PCN# : P218A
Issue Date : Oct. 17, 2012

DESIGN/PROCESS CHANGE NOTIFICATION

SPM5 SMD product Stand-off spec defined in published PKG outline drawing:
Which was 0.20 ~ 0.10mm (0.15+/-0.05mm).

Description of Change (To) :

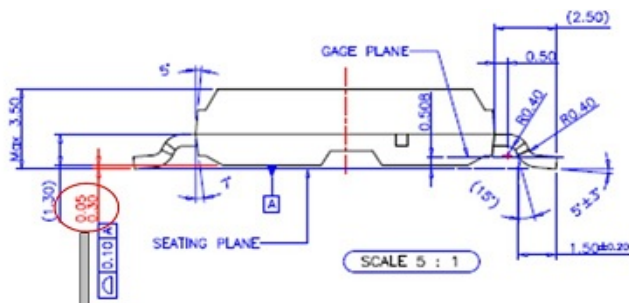
SPM5 SMD product Stand-off spec defined which is $0.30 \sim 0.05\text{mm}$ ($0.175 \pm 0.125\text{mm}$).

To correct datasheet difference from Fairchild package of drawing(POD) by our mistake.
